Pentium® Pro Processor Specification Update

Release Date: October 1997

Order Number: 242689-021

1. Mixing Steppings in MP Systems

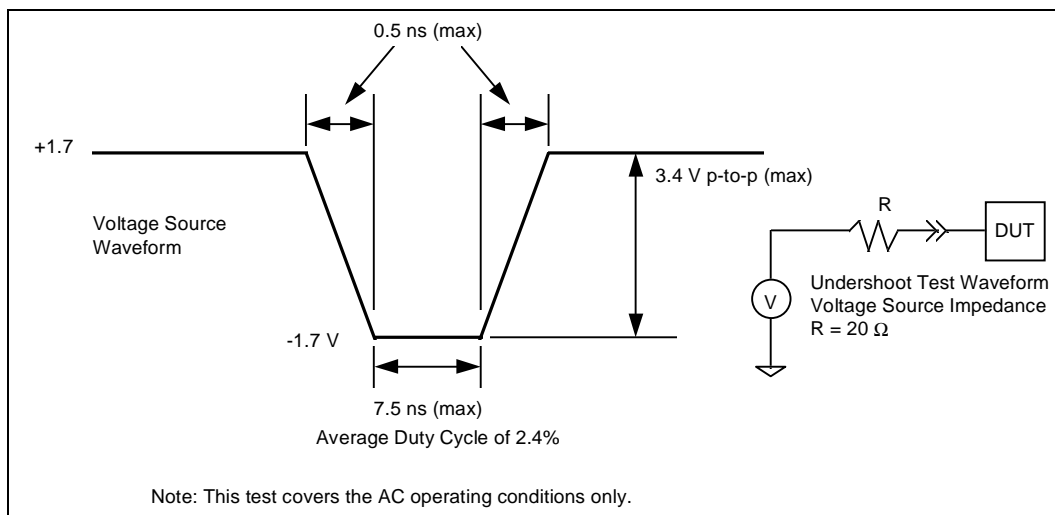
Though Intel recommends using identical steppings of processor silicon in multiprocessor systems whenever possible (as this is the only configuration which receives full validation across all of Intel's testing), Intel supports mixing processor steppings, and does not actively prevent various steppings of the Pentium Pro processor from working together in MP systems. However, since Intel cannot validate every possible combination of devices, each new stepping of a device is fully validated only against the latest steppings of other processors and chipset components.

The following list and matrix explain the known issues with mixing steppings:

- While Intel has done nothing to prevent different frequency Pentium® Pro processors within a system from working together, there may be uncharacterized errata which exist in such configurations. In mixed stepping systems, all processors must be run at an identical frequency (i.e., the *highest* frequency acceptable to all components).

- The workarounds for various errata must take all processors into account.
- Errata for all processor steppings present in a system will affect that system, unless worked around.

- The following notes apply only to specific combinations:
 1. The 150-MHz and the 166-, 180-, and 200-MHz parts vary in their GTL+ T_{CO_MIN} and T_{HOLD} timings by 250 ps. This may affect some system designs. Also, a customer may wish to use a higher frequency replacement for a 150-MHz processor in a 150-MHz system; this should also be considered.

2. OverDrive® processor upgrades for the Pentium Pro processor will only be supported in one and two processor systems, and are only supported in same stepping configurations.

3. Errata numbers 39 and 41 may be problematic for 3- or 4-way MP systems which use processor steppings previous to the sA1 stepping.

In the following table, "NI" implies that there are currently no known issues associated with mixing these steppings. An "X" implies that these steppings should not be used together in a system. A number indicates a known issue, and refers to the numbered list above. There are no currently known issues associated with mixing cache sizes.

ACTUAL vs. EXPECTED RESPONSE

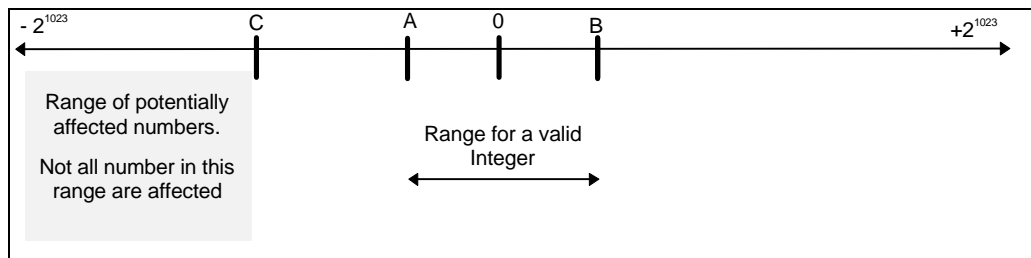
PROBLEM: On certain, large, negative, floating-point operands, and only in three of the four possible processor rounding modes, the instructions FIST[P] m16int and FIST[P] m32int do not detect that the operand is so large that it will not fit into the target data size. As a consequence, the expected Invalid Operation exception response for this

A. Actual Response:

When the required conditions are encountered, the processor provides the following response:

- Return the MAXNEG value (8000h for FIST16 & 80000000h for FIST32) to memory.
- The IE (Invalid Operation) bit in the Floating Point status word is *not set* to flag the use of an invalid operand.
- The PE (precision error) bit the Floating Point status word is *set*.
- No exception handler is invoked.
- In the case of a FISTP instruction the Operand will have been popped from the floating point stack.

B. Expected Response

The expected processor response when the invalid operation exception is *masked* is:

- Return the MAXNEG value (8000h for FIST16 & 80000000h for FIST32) to memory.
- The IE (Invalid Operation) bit in the Floating Point status word is *set* to flag the overflow.
- The PE (precision error) bit the Floating Point status word is *not set*.

Figure 4-3. Stack Switch on a Call to a Different Privilege Level

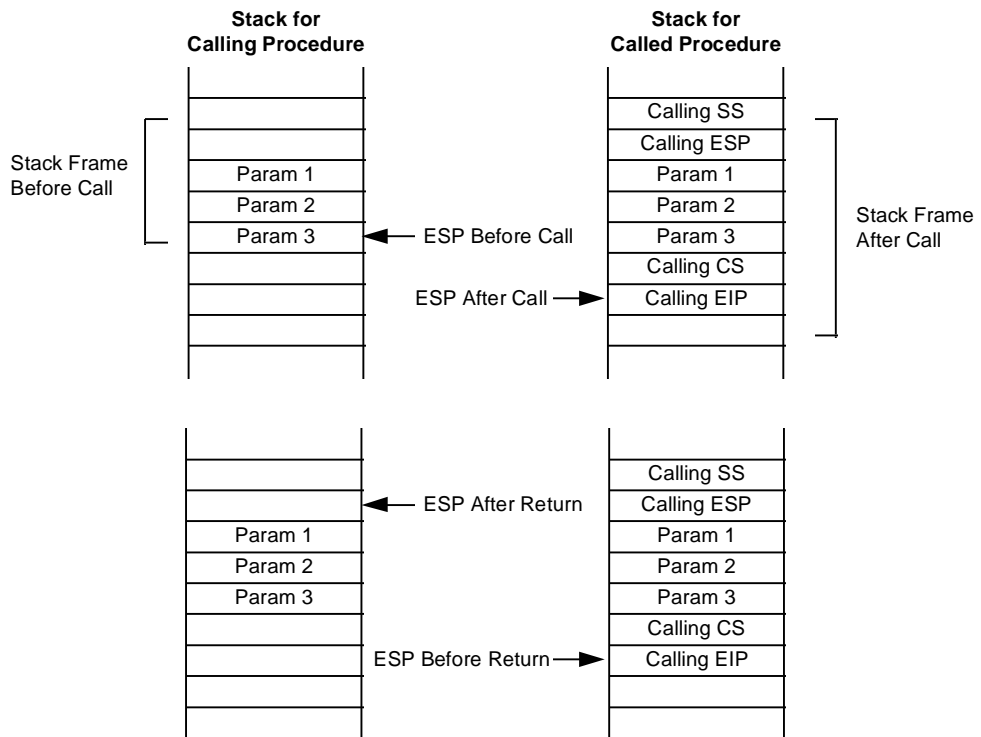
When making a call to a more privileged protection level, the processor does the following (see Figure 4-3):

3. (If the RET instruction has an optional *n* argument.) Increments the stack pointer by the number of bytes specified with the *n* operand to release parameters from the stack. If the call gate descriptor specifies that one or more parameters be copied from one stack to the other, a RET *n* instruction must be used to release the parameters from both stacks. Here, the *n* operand specifies the number of bytes occupied on each stack by the parameters. On a return, the processor increments ESP by *n* for each stack to step over (effectively remove) these parameters from the stacks.

4. Restores the SS and ESP registers to their values prior to the call, which causes a switch back to the stack of the calling procedure.
5. (If the RET instruction has an optional *n* argument.) Increments the stack pointer by the number of bytes specified with the *n* operand to release parameters from the stack (see explanation in step 3).

6. Resumes execution of the calling procedure.

Figure 4-4. Stack Usage on Transfers to Interrupt and Exception Handling Routines

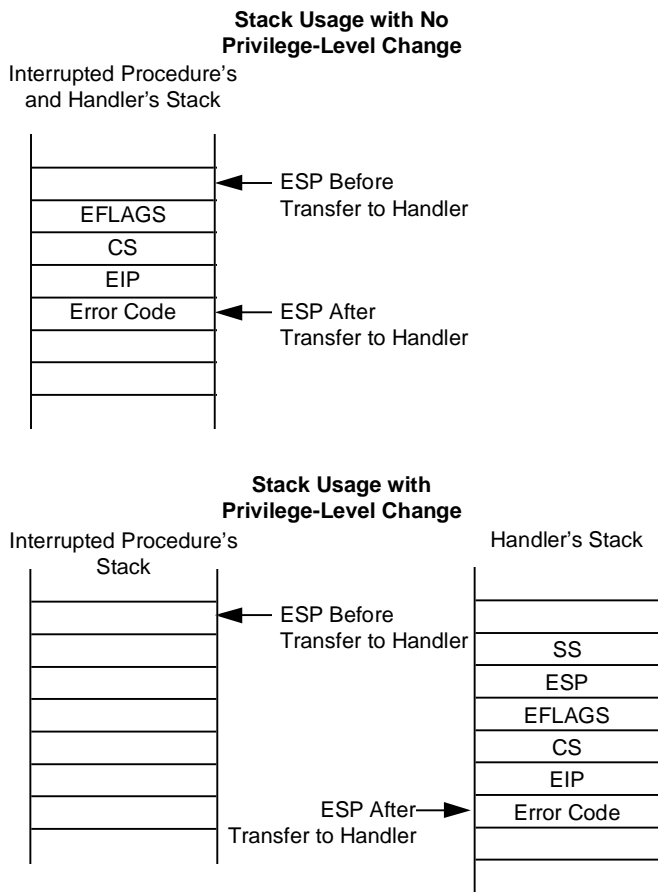
If no stack switch occurs, the processor does the following when calling an interrupt or exception handler (see Figure 44):

When executing a return from an interrupt or exception handler from a different privilege level than the interrupted procedure, the processor performs these actions:

1. Performs a privilege check.
2. Restores the CS and EIP registers to their values prior to the interrupt or exception.
3. Restores the EFLAGS register.
4. Restores the SS and ESP registers to their values prior to the interrupt or exception, resulting in a stack switch back to the stack of the interrupted procedure.
5. Resumes execution of the interrupted procedure.
